Q. UNR166

Part II - Vehicle Installation of Means of Front and Lateral Vision or Detection

12.2. "**Ambinocular vision**" means the total field of vision obtained by the superimposition of the monocular fields of the right eye and the left eye (see Figure 1 below).

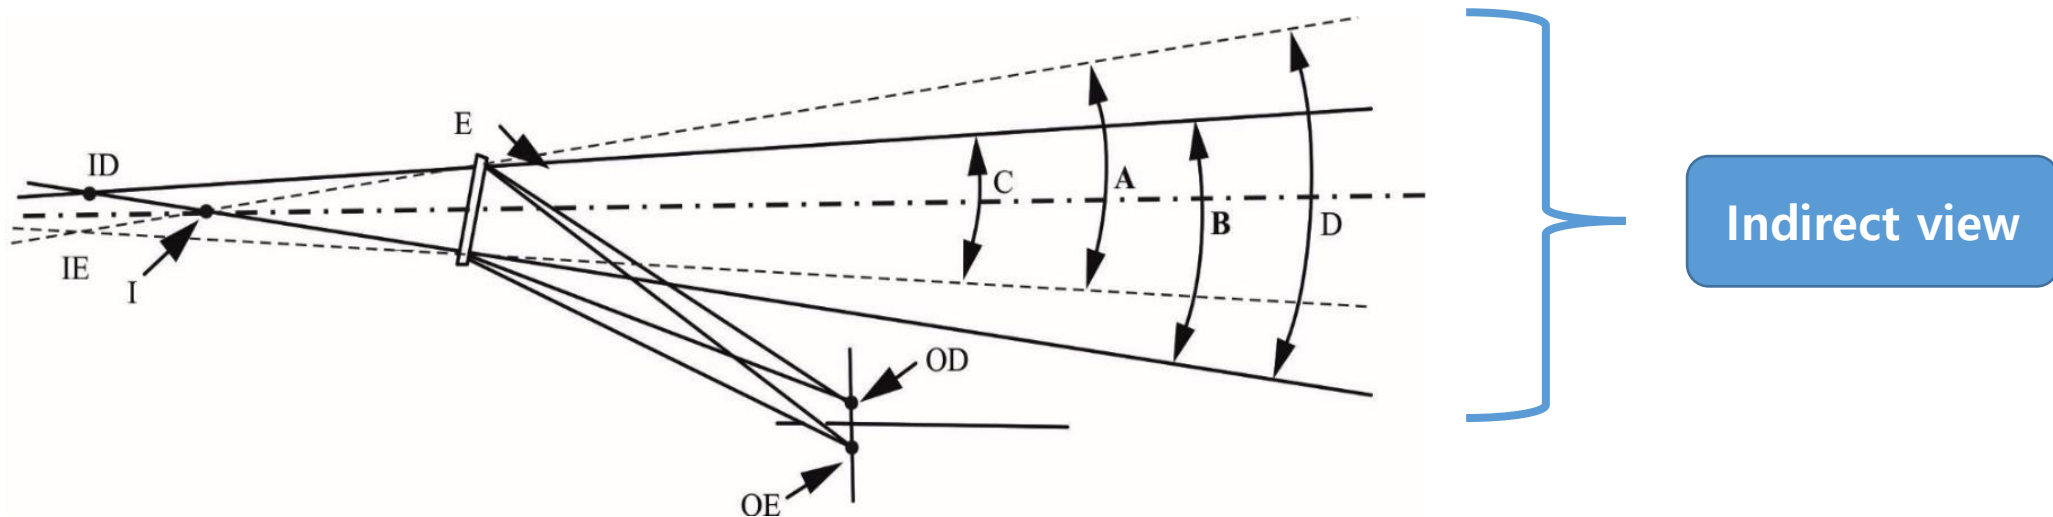
- Close-proximity front and lateral sides field of vision via
 1. the direct view from ambinocular vision, or
 2. the direct view from binocular vision
- It seems that the Figure 1 (Monocular Fields) only show “Indirect view”.

- Where is “**the direct view**” in the Figure 1?
